Hillsborough County Florida

SM
STAFF REPORT

SUBJECT:	PRS 20-0977	PLANNING AREA:	Thonotosassa
REQUEST:	Minor Modification to PD	SECTOR	Central
APPLICANT:	Brothers Four of Tampa, LLC		
Existing Zoning: PD 05-0201 (PRS 18-1464)		Comp Plan Category: RES-1

Figure 3: Proposed 20-0977 site plan

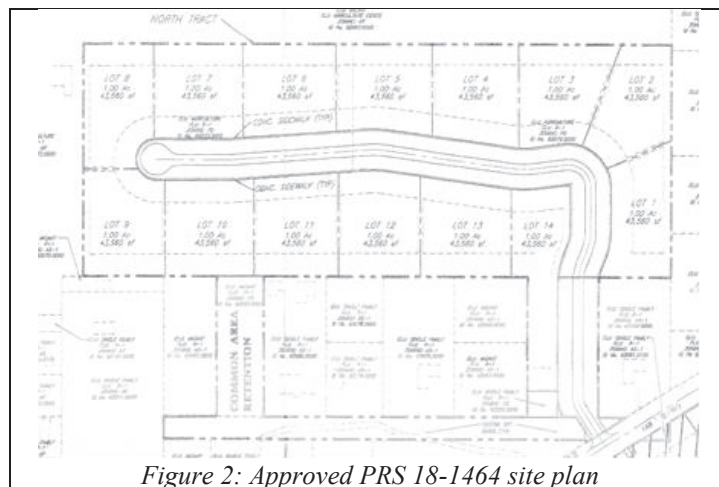
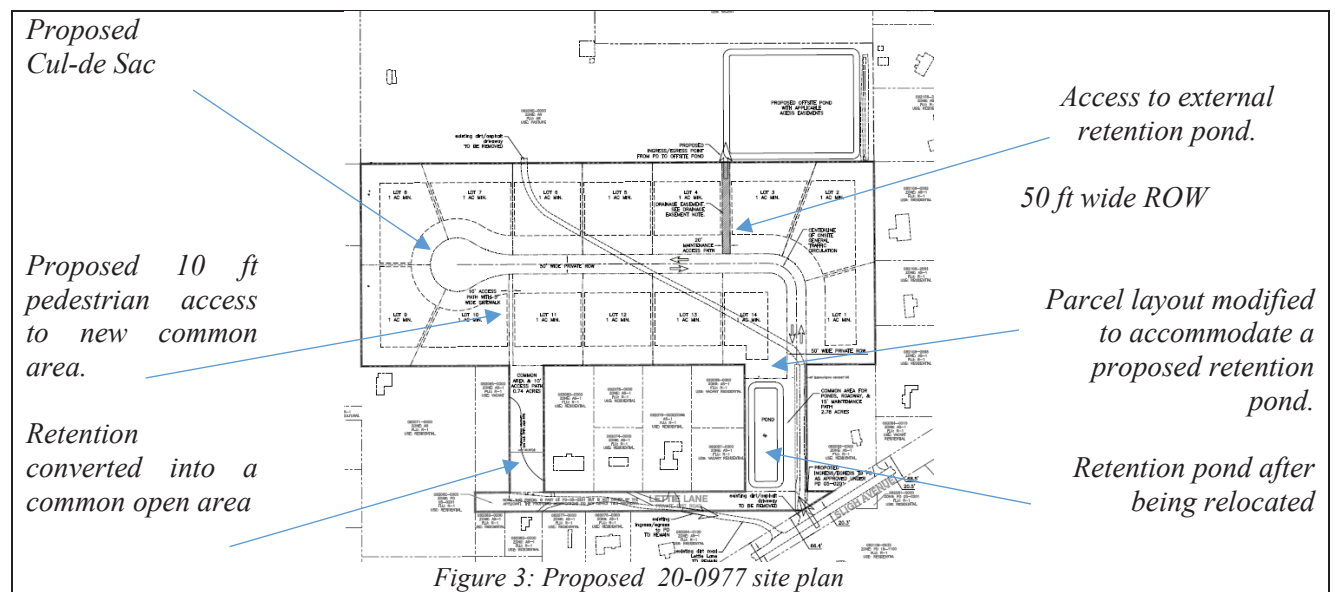
The applicant is proposing the following changes to the site plan:

- Addition of an offsite maintenance access to a proposed offsite pond that will serve the future subdivision.
- Expansion of the internal right-of-way to accommodate a cul-de-sac.
- Modification the of the internal roadway to straight the ROW path line.
- Reduction of the right-of-way to 50 ft
- Provision of an internal access to the common area labeled “Common area retentions”.
- Relocation of a retention pond to the Subdivision entrance area.
- Lots layout rearrangement to accommodate the modifications above.

Staff finds the proposed request to be compatible with the surrounding area. This minor modification will have little effect on the general character of the subject site, zoned PD today. Relocating the retention pond, providing access to an external pond, and providing a new common area will not result in a greater impact on the adjacent residential lots.

Based on all of the above, staff recommends approval, with conditions and changes to the site plan.
